MEMORANDUM

Subject: DOE Comments on 881 Hillside RI/FS

Date: October 17, 1988

Figure 2. Bis(2-ethylhexyl)phthalate Profiles at SWMU 119.1

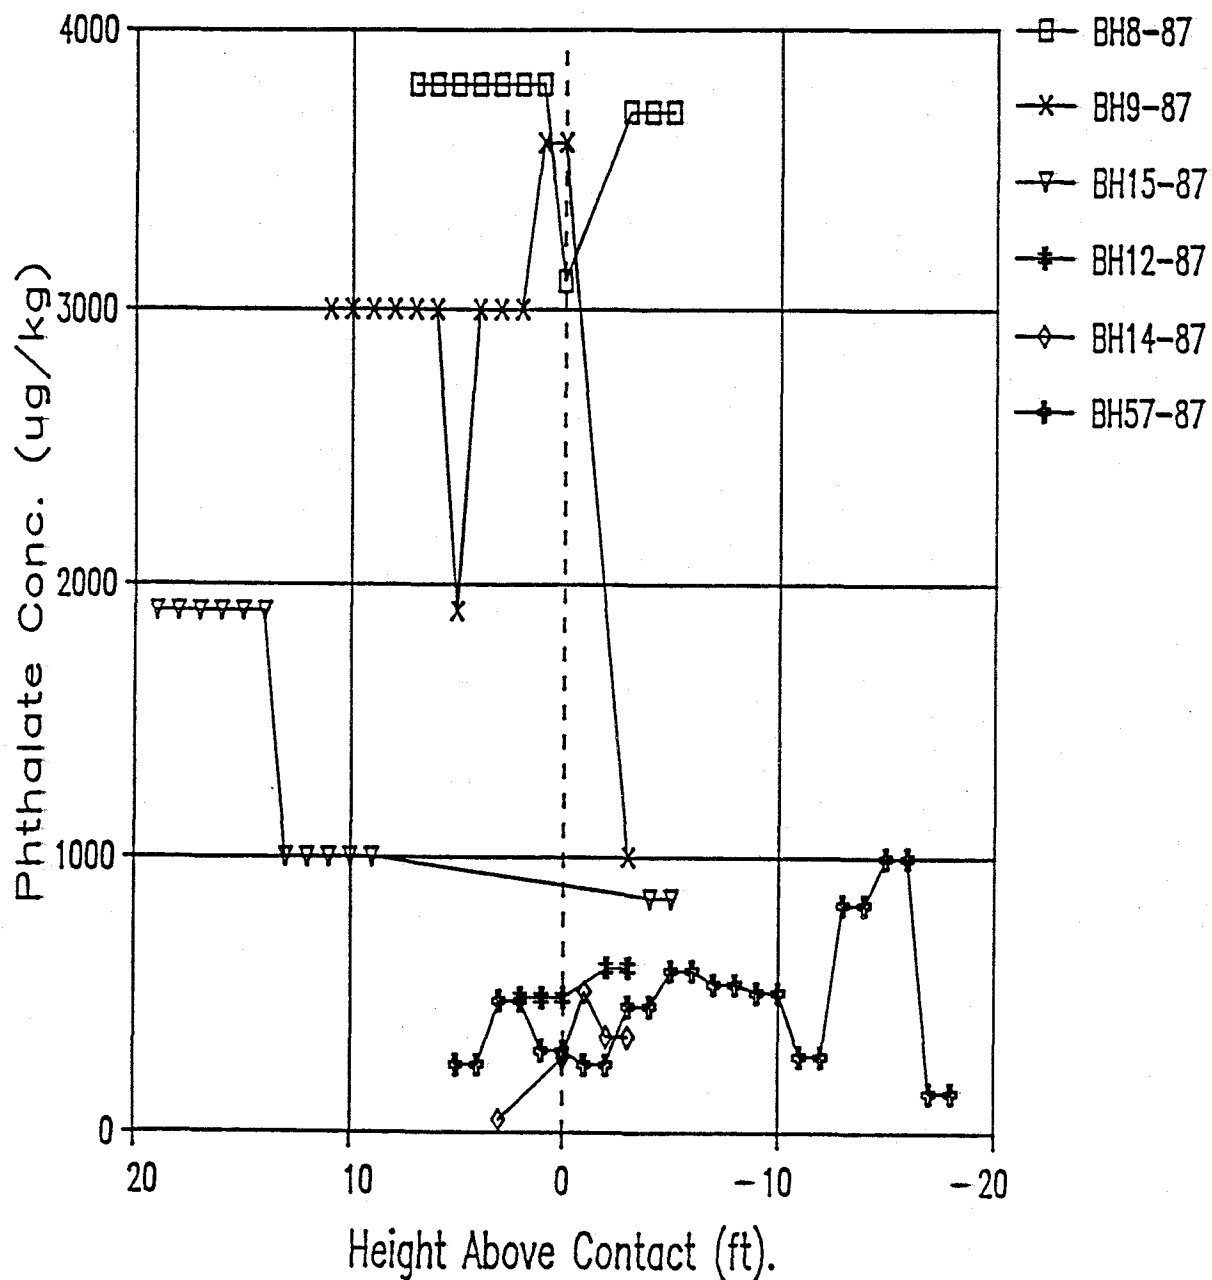
Soil gas detection at the northern perimeter of the 881 Hillside area and soil contamination (primarily bis(2-ethylhexyl)phthalate) at boreholes topographically and hydraulically up-gradient of SWMU 119.1 (boreholes BH9-87, BH15-87, and BH8-87) suggest contamination from source(s) above the hillside and just west of the stock piles. The RI should discuss the source of this possible contamination and consider extending boreholes and/or soil gas samples northward.

Bis(2-ethylhexyl)phthalate concentrations are definitely elevated up-hill from SWMU 119.1 as compared to samples obtained from within the SWMU area. This is shown in Table 3 and diagrammatically on Figure 2. It is hypothesized that the bis(2-ethylhexyl)phthalate concentrations in excess of about 1,000 ug/kg are significant concentrations and that the lower concentrations (all within the SWMU itself) may be residual levels after extraction by waste solvents. The concentrations uphill probably result from drum storage; the SWMU should probably be extended to include these areas.

It is the opinion of the FS team that additional investigation of uphill areas is not warranted, given the nature of the recommended remedial action. Because the french drain will capture all colluvial ground-water flow, the exact locations of sources is not critical to the performance of the system.

Figure 3. 59-86BR SANDSTONE IN CROSS SECTION

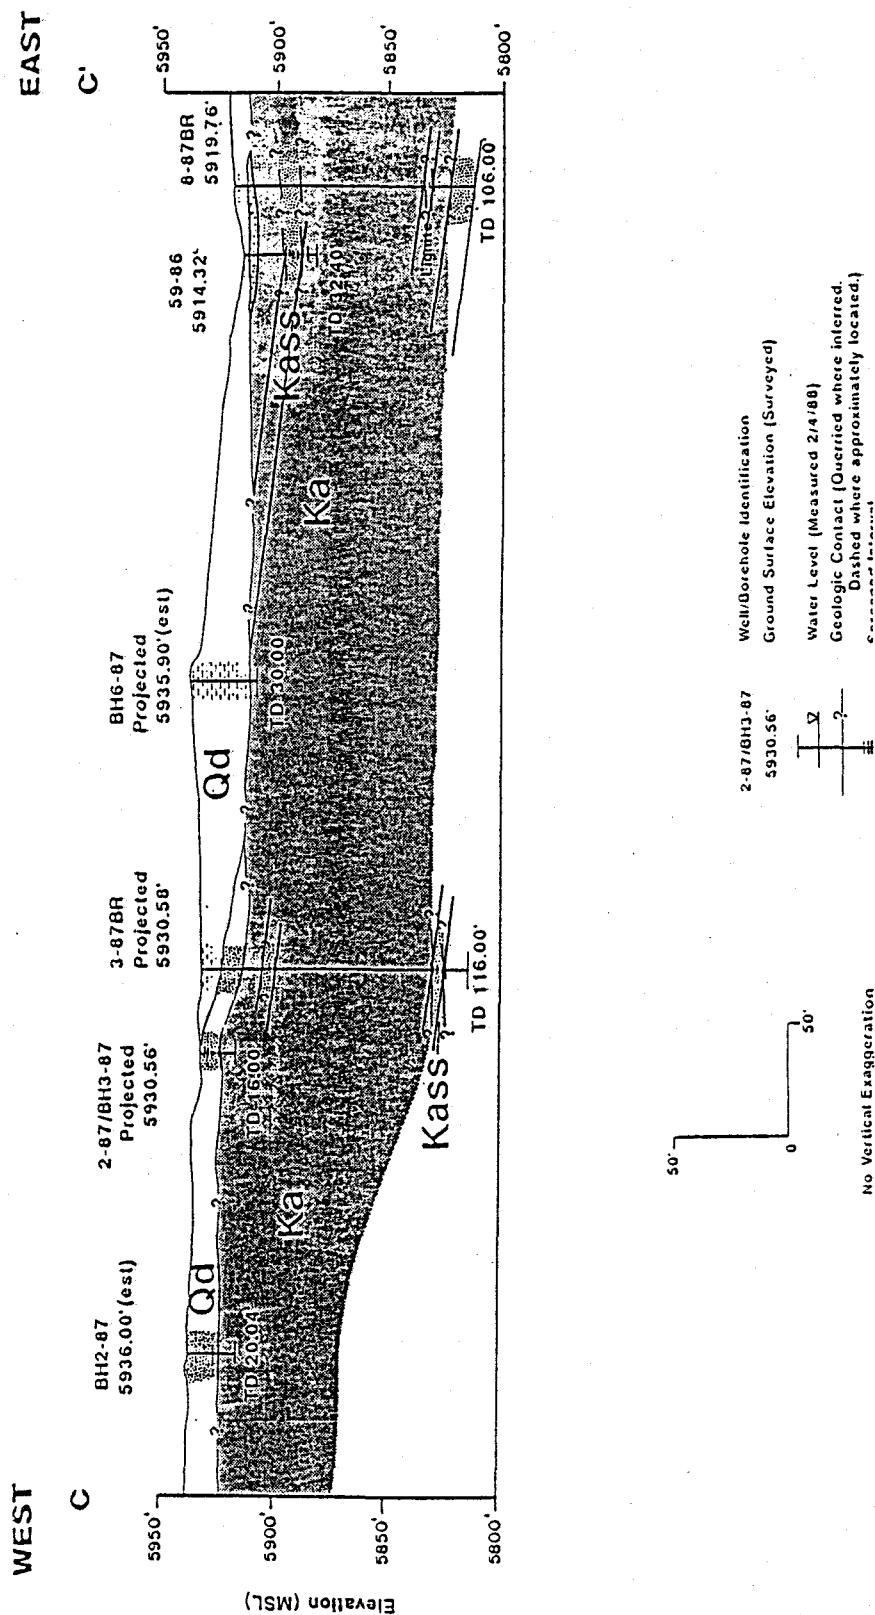
A primary concern with the work done to date at the 881 Hillside is the degree to which the potential for bedrock contamination, both current and future, has been evaluated. The discussion in Section 5.4.3.1 indicates elevated uranium in the uppermost bedrock aquifer at 59-86BR as well as similar groundwater chemistry and selenium concentration to the overlying alluvial groundwater. Considering the proposal to leave waste in place and treat alluvial groundwater, a subcropping sandstone aquifer in the vicinity of Building 881 has a potential for bedrock contamination during the operational life of the treatment facility. Consideration should be given to placing one or two shallow bedrock aquifer wells down-gradient and slightly east of the three well cluster to indicate if suspected bedrock contamination persists down-gradient and down-dip. Also a concentrated geophysical survey combined with a limited number of boreholes in the area bounded by boreholes 59-86BR, BH63-87, BH53-87 and

BH3-87 could be implemented to specify the suspected area of bedrock/alluvium communication.

Two seemingly superficial, yet quite significant points should be made with regard this comment.

First, the only bedrock sandstone units that even begin to behave like aquifers beneath the Rocky Flats Plant have been found near the 903 Pad. Otherwise, bedrock consists of low permeability claystone and relatively low permeability sandstone. It does neither Rockwell nor DOE any good to call the sandstone unit at the 881 Hillside an aquifer. Note that the sandstone in 59-86BR has a saturated thickness of 3.5 feet or less and a hydraulic conductivity of 3×10^{-4} cm/s. These data imply that the maximum sustainable pumping rate from a well completed at this location is less than 0.1 gpm; clearly this unit should not be called an aquifer.

Nonetheless, the RI team shares the concern expressed by the reviewer with regard the evaluation of bedrock contamination. Detailed discussions together with supporting data are presented in the RI dealing with the evaluation of chemical conditions in the bedrock. The essence of the discussions is presented in Table 4 and can be summarized as follows.

1. At SWMU 119.1, bedrock ground water is distinctly different from colluvial ground water (based on major ion, uranium and organic differences); therefore, colluvial ground water is in poor connection with bedrock ground water and there is little potential for impact to the bedrock ground water.
2. At SWMUs 103, 106 and 107 (south of Building 881), deeper bedrock ground water is distinctly different from colluvial and shallowest bedrock ground water (based primarily on uranium differences); however, shallowest bedrock ground water cannot be differentiated from colluvial ground water and the two systems appear to be well connected based on chemical similarities. The effects of lithologic variation

3. Although the colluvial and shallowest bedrock ground waters appear connected at the three well cluster, neither of these waters is contaminated. Uranium is the only constituent that could be considered a contaminant, and it is not considered to be a problem because the concentrations are low (less than even the proposed drinking water standard) and because it appears to be natural uranium rather than either enriched or depleted uranium.

Based on these observations, the RI team concluded that there is currently no bedrock ground-water contamination.

The potential for future degradation of water quality in the shallow sandstone at the three well cluster is considered minimal because of the location of the french drain. The connection between the shallowest bedrock ground water and the colluvial ground water is presumed to be at the subcrop of the sandstone. Based on a seven degree dip to the east, the sandstone subcrops slightly east of BH6-86 (Figure 3). Figure 4 shows the presumed location of the subcrop in plan view, together with the location of the french drain. If the sandstone were continuous, there is potential for future impact to the bedrock system. However, the drain alignment has been drilled since preparation of the RI (Figure 5 shows boring locations as presented in Aguirre, 1988), and all of the borings found claystone bedrock. Therefore, it is concluded that the sandstone is not sufficiently extensive to present a potential conduit for flow of contaminated water from areas upgradient of the french drain into the bedrock system.

Figure 5. AGUIRRE (1988) DRILLING LOCATIONS

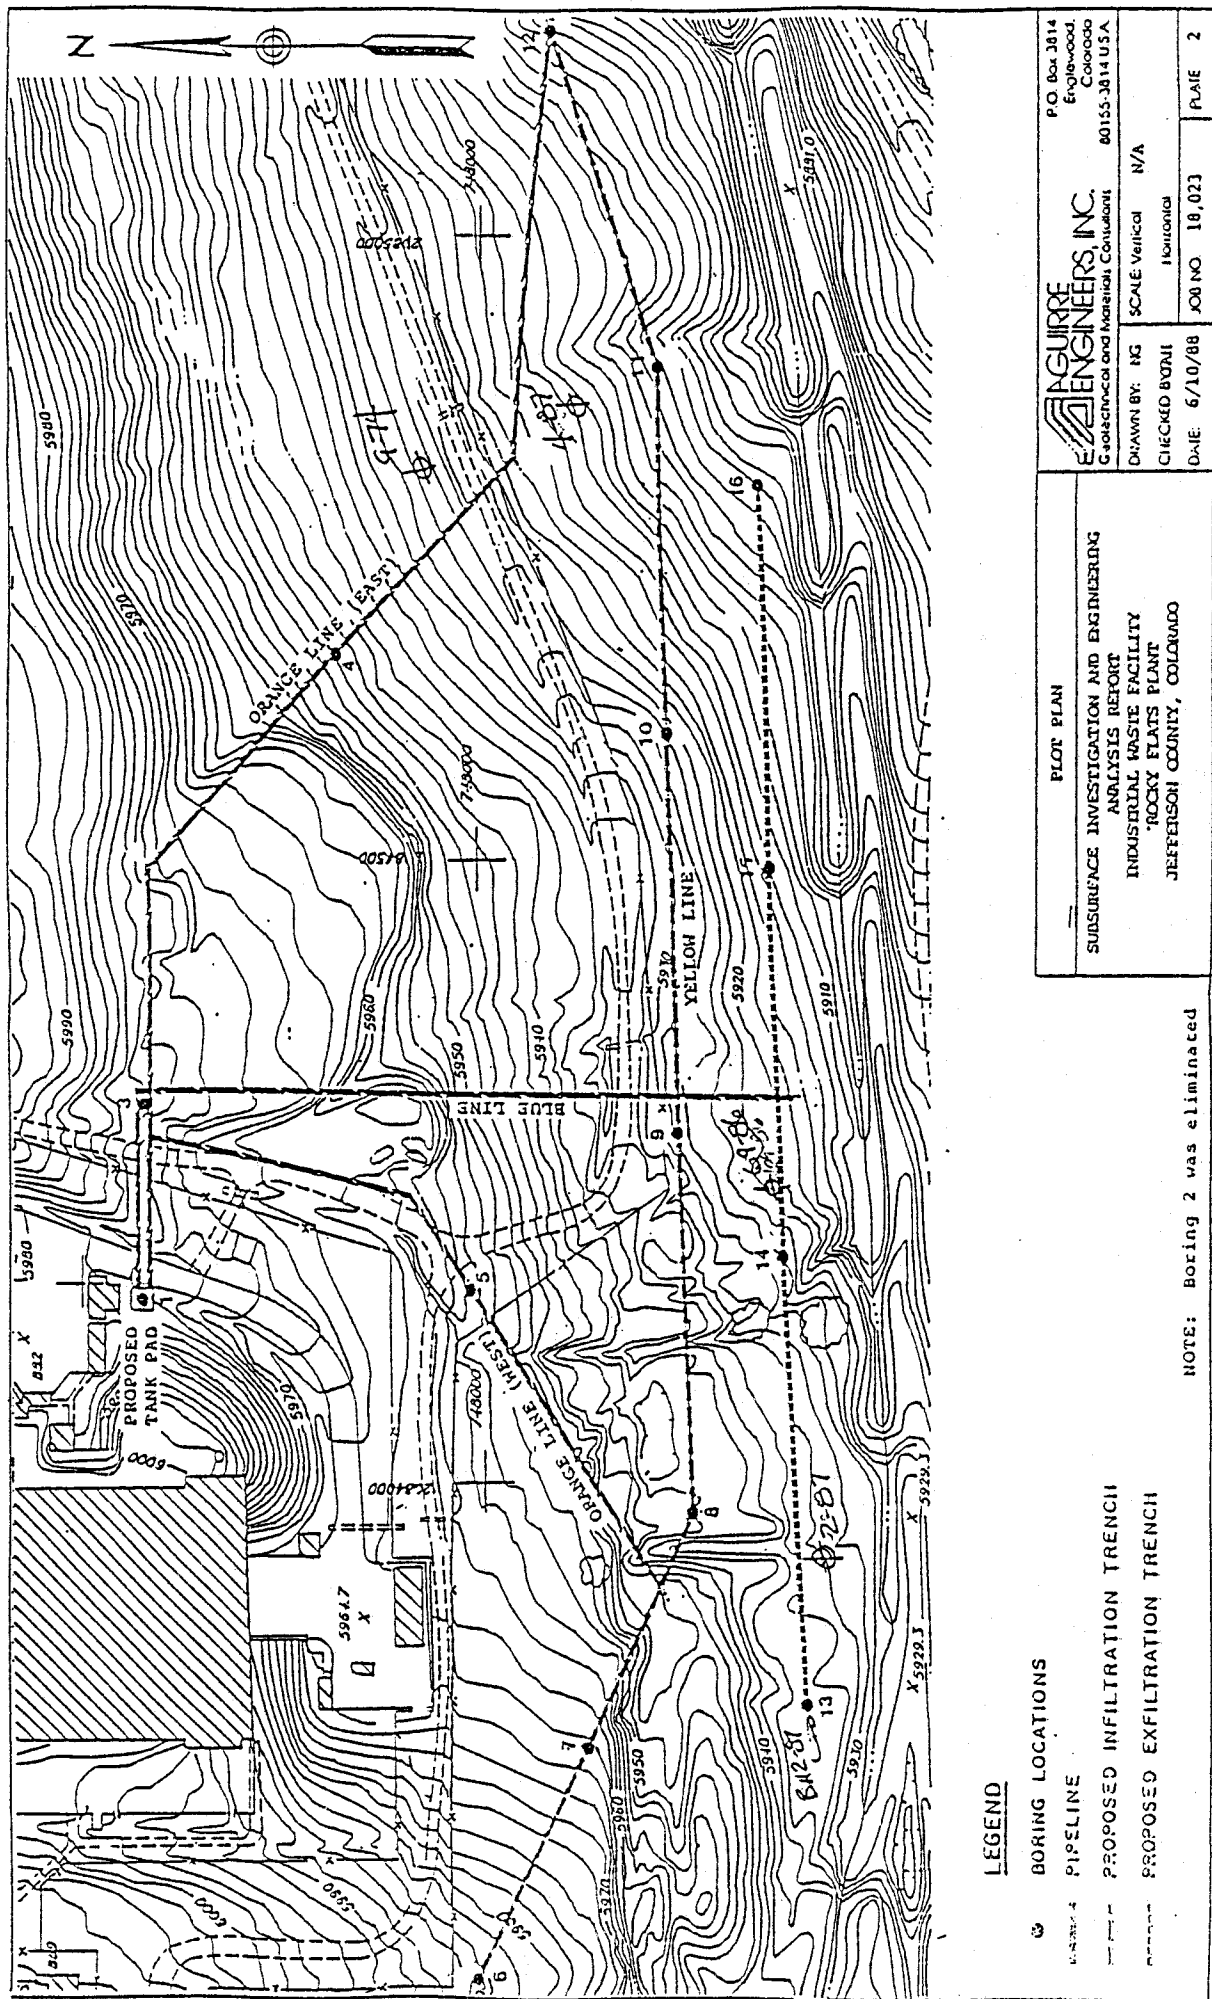
The farthest wells down-gradient of SWMUs 102, 106, and 107 (3-87BR, 69-86, 59-86BR, 8-87BR, and 2-87) all show semi-volatile and volatile organic contamination and therefore do not bound the contaminant plumes from the area south of Building 881. Although downgradient alluvial wells 68-86 and 53-87 are not contaminated, there is a significant gap (about 1500') between them. Considering the heterogenous composition of the alluvium, an alluvial well between 68-86 and 53-87 would confirm that no further southeasterly contamination has occurred and the plume is contained north of Woman Creek. The same comment applies to the gap between wells 64-86 and 65-86 downgradient of SWMU 119.1.

Ground-water samples from the above-mentioned wells downgradient of Building 881 do not exhibit either volatile or semi-volatile contamination. Volatile organic data from the RI are presented in Appendix A. The data for each of the wells are as follows.

Based on all of the above, it is the opinion of the RI team that the organic problem behind Building 881 has been bounded by the existing wells.
